CHESAPEAKE SUBDIVISION,

UNIT 2

APPLICATION NUMBER 10 DATE May 21, 2015

REQUEST Subdivision

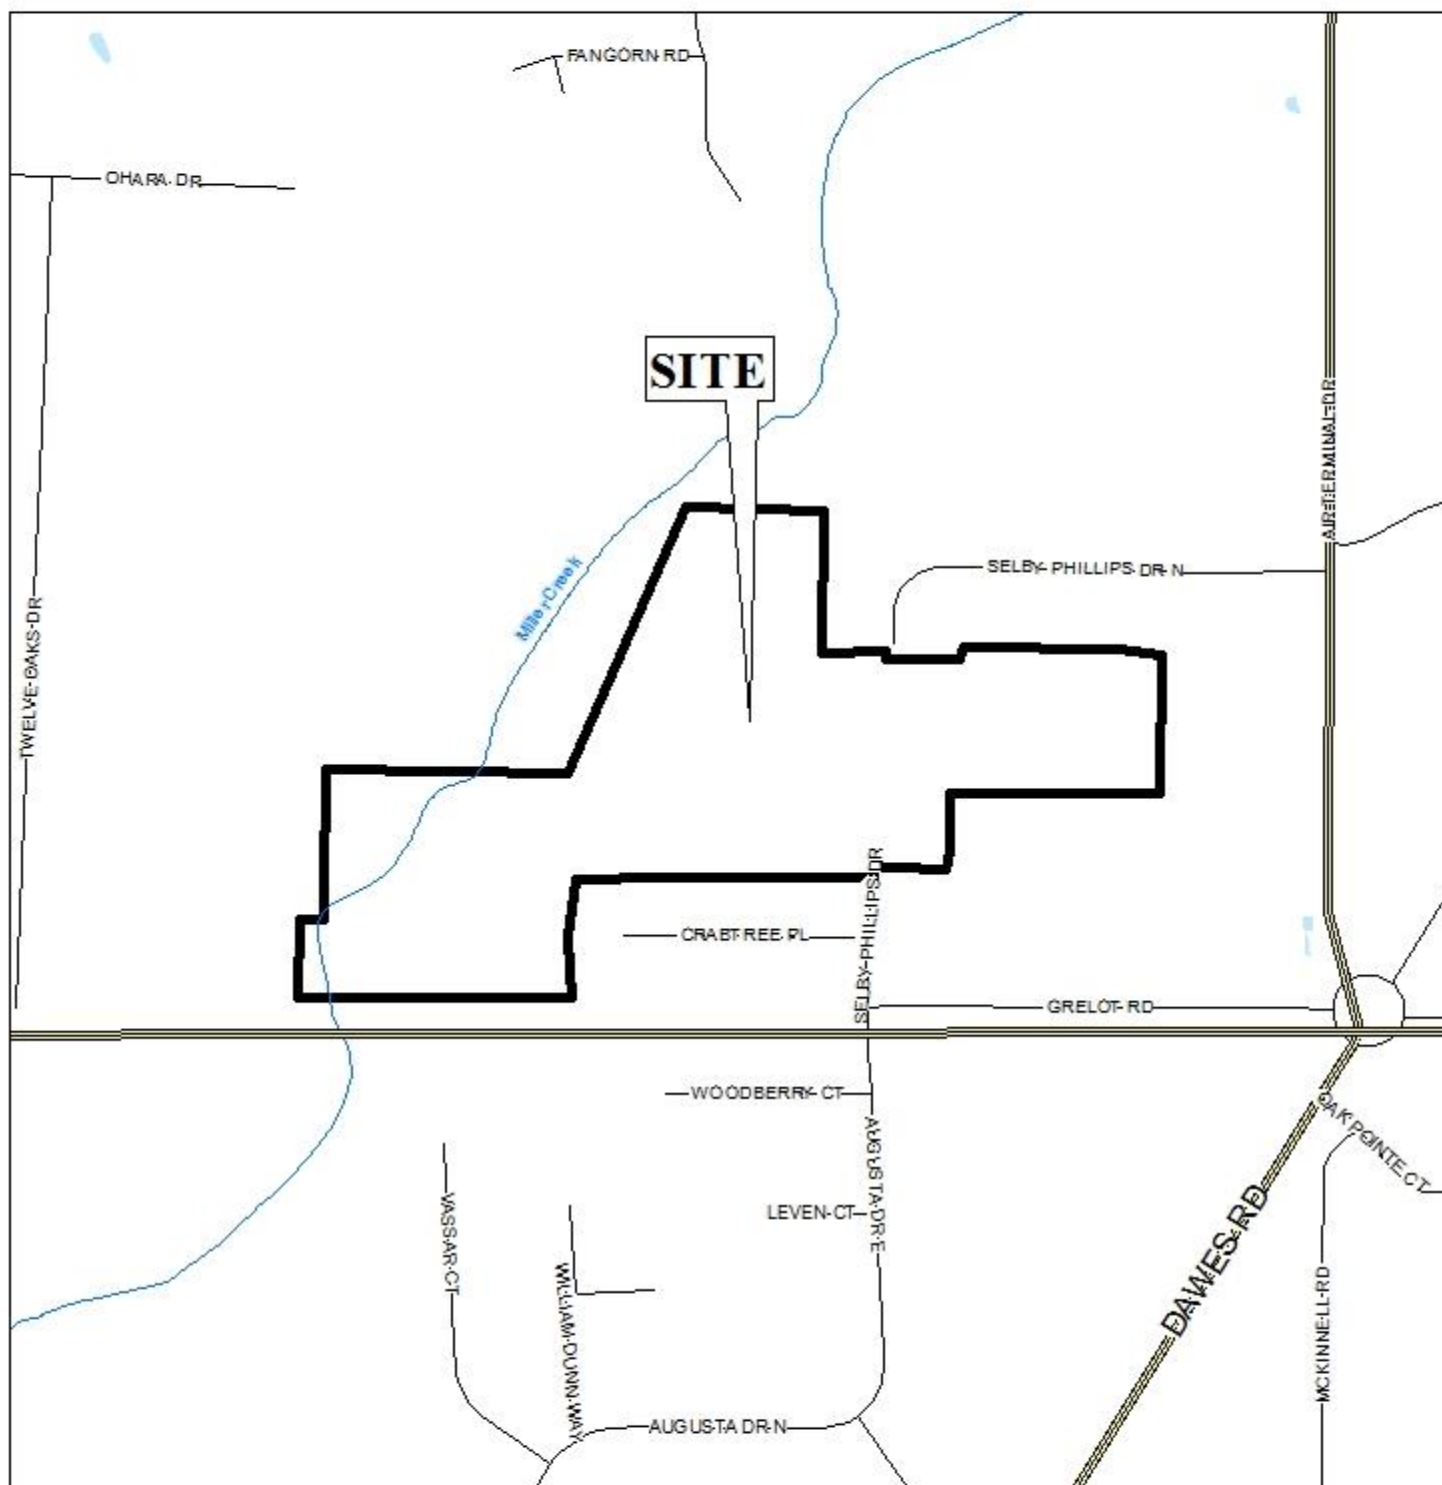
The preliminary plat illustrates the proposed 51-lot, 30.0± acre subdivision which is located on the West side of Air Terminal Drive at the North terminus of Selby Phillips Drive North. The site is within the Planning Jurisdiction and the applicant states that the subdivision is served by city water and sewer.

In accordance with the Subdivision Regulations, all proposed lots appear to exceed the minimum lot size requirements and the 25' minimum building setback line is depicted on the preliminary

plat. However, the Final Plat should be revised to label the lots with their sizes in both square feet and acres, or a table should be furnished on the Final Plat providing the same information. The 25' minimum building setback line for all lots should be retained on the Final Plat.

Proposed Lot B fronts an unopened portion of Grelot Road, a component of the Major Street Plan with a compliant 100' right-of-way; therefore, no dedication would be required. As a means of access management, Lot B should be limited to one curb cut to Grelot Road, once the road is constructed, with the size, design and location to be approved by Mobile County Engineering and conform to AASHTO standards.

As a means of access management, a note should be placed on the Final Plat limiting all proposed lots to one curb-cut each, with the size, design and location to be approved by Mobile County Engineering and conform to AASHTO standards.

The site has frontage along two street stubs of Selby Phillips Drive, with a compliant 50' right-of-way width. The preliminary plat depicts the continuation of Selby Phillips Drive along with the construction of three additional streets – Kari Court, Creek Ridge Court and Oak Ridge Court. The right-of-way width of all proposed streets within the subdivision is 50', as compliant with Section V.B.14. of the Subdivision Regulations. The proposed turnaround at the terminus of each proposed street is depicted with a 120' right-of-way width, also compliant with the Subdivision Regulations. If approved, all proposed streets must be built to Mobile County Engineering standards and be accepted by Mobile County prior to the signing of the Final Plat.

The preliminary plat illustrates a 2.97± acre common area and, if approved, the Final Plat should include a note stating that the maintenance of all common and detention areas shall be the responsibility of the property owners and not Mobile County.

The plat also depicts the presence of several easements throughout the site and, if approved, a note should be placed on the Final Plat stating that no permanent structures can be placed or erected within any easement.

The plat meets the minimum requirements of the Subdivision Regulations and is recommended for Tentative Approval, subject to the following conditions:

- 1) submission to the Planning Division of the required seven copies of the recorded Pritchard Subdivision prior to the signing of the Final Plat for Unit 2;
- 2) submission to the Planning Division of the required seven copies of the recorded Chesapeake Subdivision, Unit 1, prior to the signing of the Final Plat for Unit 2;
- 3) submission to the Planning Division of the required seven copies of the recorded Rosefield Subdivision prior to the signing of the Final Plat for Unit 2;
- 4) revision of Final Plat to label all lots with their sizes in both square feet and acres, or the furnishing of a table on the Final Plat providing the same information;
- 5) retention of the 25' minimum building setback line along all street frontages;

- 6) placement of a note on the Final Plat stating that Lot B is limited to one curb cut to Grelot Road, once the road is constructed, with the size, design and location to be approved by Mobile County Engineering and conform to AASHTO standards;

- 7) placement of a note on the Final Plat stating that all lots are limited to one curb cut, with the size, design and location to be approved by Mobile County Engineering and conform to AASHTO standards;

- 8) placement of a note on the Final Plat stating no future subdivision of Lot B will be allowed until additional frontage along a paved, public or private street is provided;

- 9) placement of a note on the Final Plat stating that all proposed streets must be built to Mobile County Engineering standards and be accepted by Mobile County prior to the signing of the Final Plat;

- 10) placement of a note on the Final Plat stating that the maintenance of all common and detention areas is the responsibility of the property owners and not Mobile County;

- 11) placement of a note on the Final Plat stating that no permanent structures can be placed or erected in any easement;
- 12) placement of a note on the Final Plat stating that any lots which are developed commercially and adjoin residentially developed property must provide a buffer, in compliance with Section V.A.8. of the Subdivision Regulations;
